# UNITED STATES PATENT AND TRADEMARK OFFICE

| APPLICATION NO.  | FILING DATE | FIRST NAMED INVENTOR | ATTORNEY DOCKET NO. | CONFIRMATION NO. |
|--|-------------|----------------------|---------------------|------------------|
| 10/564,226   | 05/31/2006  | Franz Thoemmes       | 10191/4495          | 7534             |

# Office Action Summary

## DETAILED ACTION

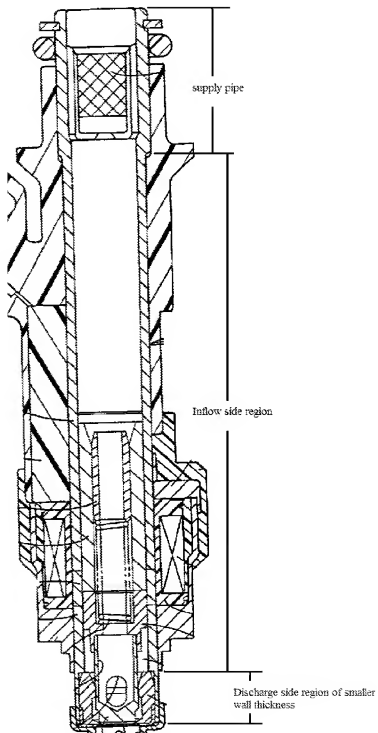
Claim 8 is rejected under 35 U.S.C. 102(e) as being anticipated by Aoki et al. (US 2002/0170987).

Aoki et al. shows a fuel injector (1) comprising; a valve needle (26) an armature (25) forming an axially movable valve port together with the valve needle, a restoring spring (24) acting upon the armature, a magnetic coil (31) cooperating with the armature, a valve-seat body (26), a valve closure member (28a) which forms a sealing seat with the valve seat body and; a valve sleeve (14) surrounding the armature and the valve needle, a wall thickness of the valve sleeve varying across its axial direction (fig

2), wherein the wall the wall thickness of the valve sleeve decreases in a discharge direction of a fuel (figure 2), wherein a radial cross section of the valve sleeve decreases between an inflow-side region and a discharge-side region on a color (figure 2), wherein the radial cross section and the wall thickness of the inflow-side region are constant from the collar to an inflow-side end of the valve sleeve (figure 2); wherein the decreased radial cross section and decreased wall thickness of the discharge-side region are constant from the collar to a discharge-side end of the valve sleeve (see examiners marked up figure below), and wherein the inflow side region of the valve sleeve is formed in one piece with a supply pipe (see examiners marked up figure below).
